Heritage KMR.CDD.GaQ.1920.05

ORDER UNDER SECTION 96 (2) OF ACT, III OF 1901.

that the plan submitted by him for building a house

PLAN SHOWING PROPOSED BUILDING
ON PLOT No. 9/5 SHEET No. D-3
GARDEN QUARTER
SCALE 8 FEET = 1 INCH

PLAN OF GROUND FLOOR.

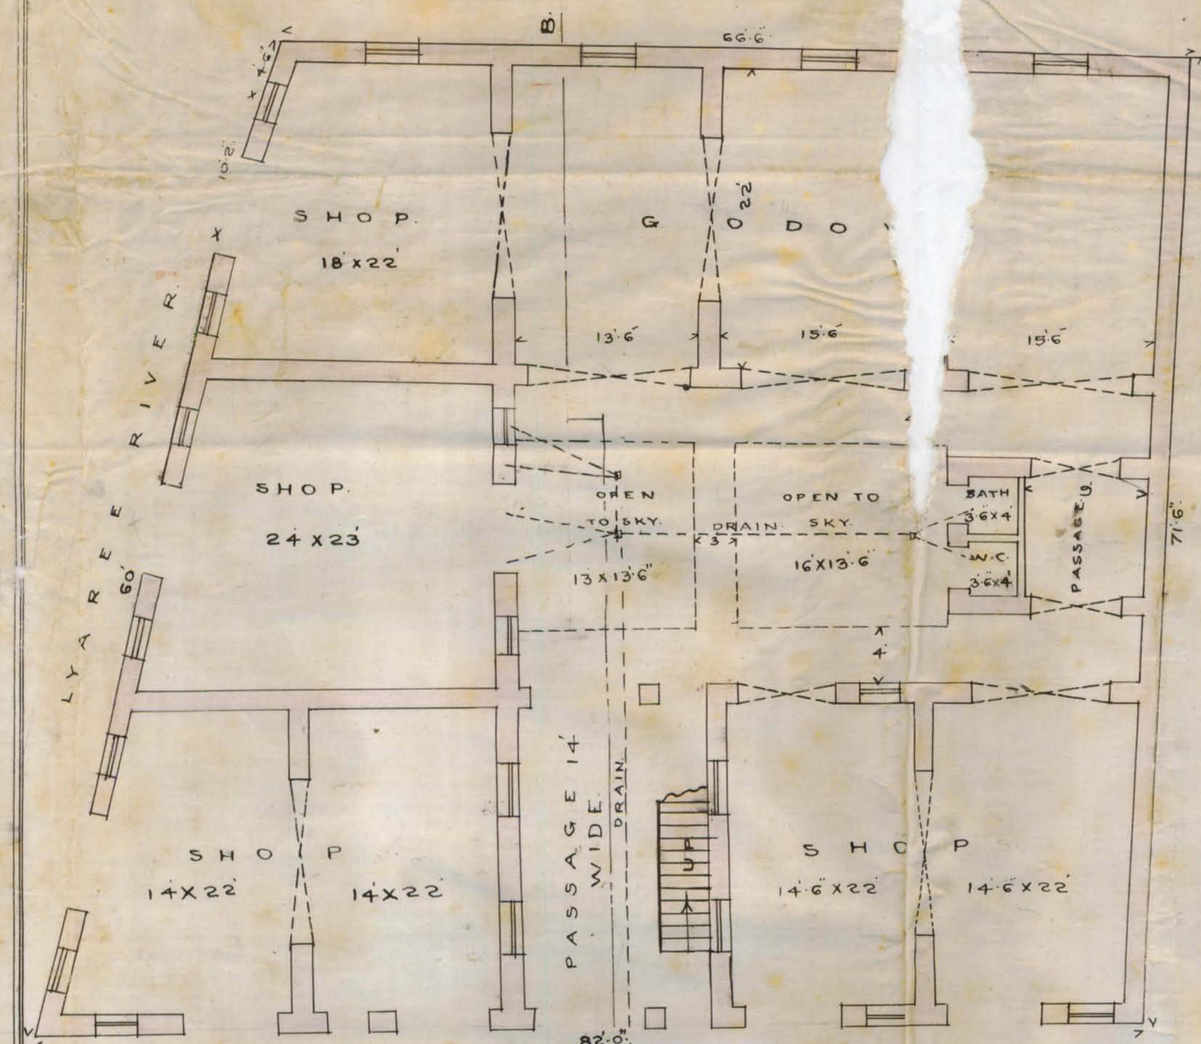
Godowns to have through ventilation by placing windows at the back. The back rooms take opened to the light

(1) I have provided high level windows in the back of the godowns for through ventilation.

PLAN OF 1ST & 2ND FLOOR.

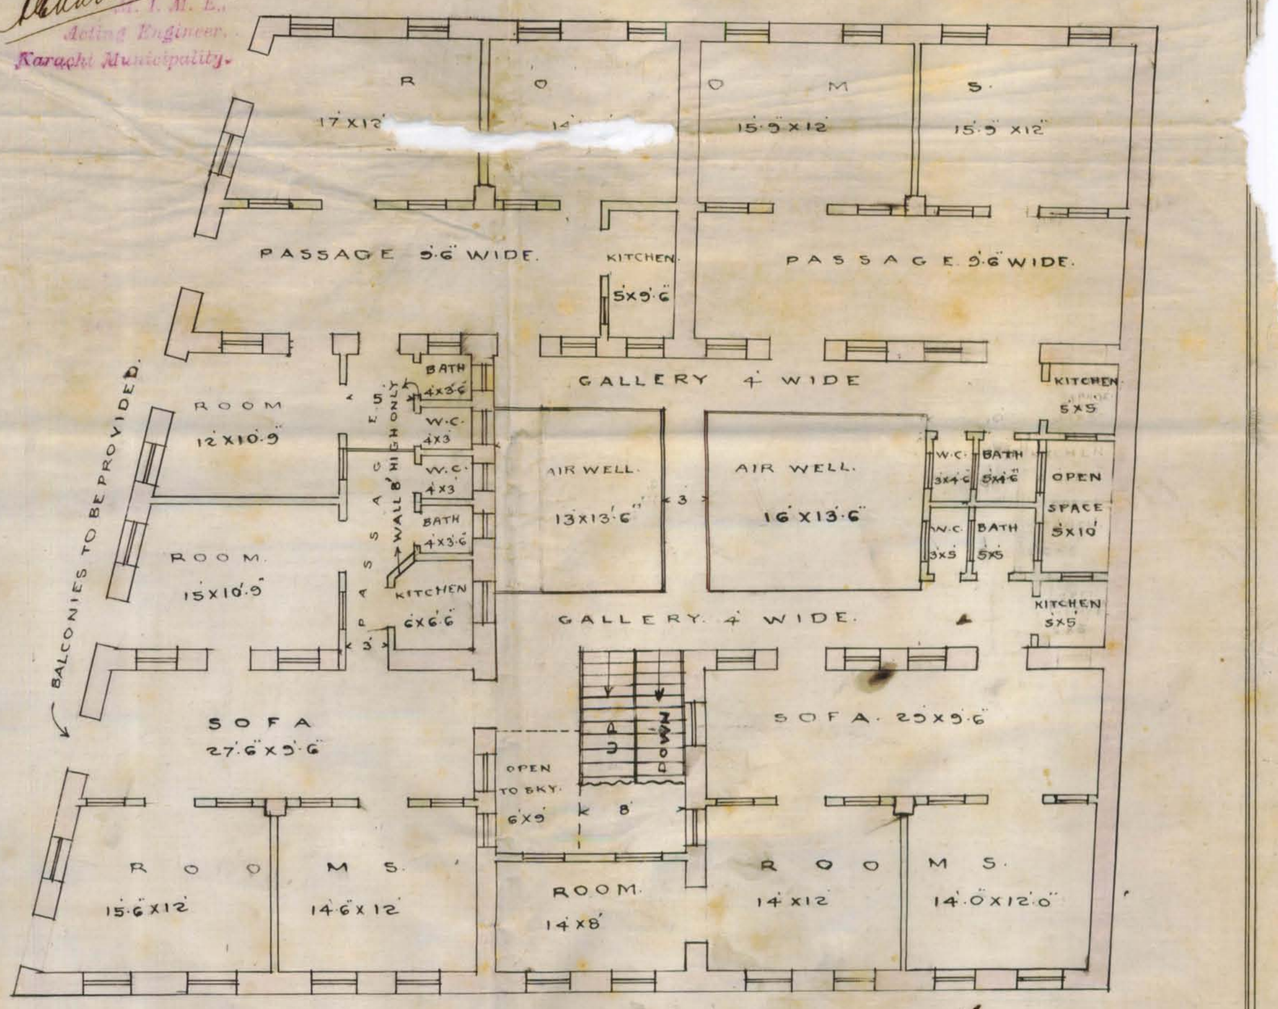
With reference to his letter dated 4th Instant with a plan for the proposed building on plot No. 9/3, D-3 Garden Quarter Mr. Lilaram Sobhraj is informed, the arrangement of ventilation of baths through water closet is not satisfactory.

The kitchens may be converted into air wells and the air wells 4 x 5 into kitchens.

The gallery hatched in pencil is not required and must be deleted to increase the air space.

With reference to his application dated 14th August 1920 with a plan for the proposed building to be erected on plot No. 9/5, D-3 Garden Quarter Mr. Lilaram Sobraj is informed, the godowns shown on such plan must have through ventilation by placing windows at the back. The bath rooms to be opened to the light.

Bathrooms on the upper floors situated in the east corner of the building will be totally dark

(2) The bath rooms are located adjacent to the W.C.s with windows in the partition wall between the bath & W.C. the latter is abutting directly to the open Space (air well)

With reference to your No. L.S. 5534 of 28th ultimo, I beg to return herewith the plans of my house on plot No. 9/5, D.3. Garden Rd and to state that the plans have again been amended in accordance with your remarks contained in the memo cited above, I therefore request you will now kindly approve the plans as the same has been pending since long.
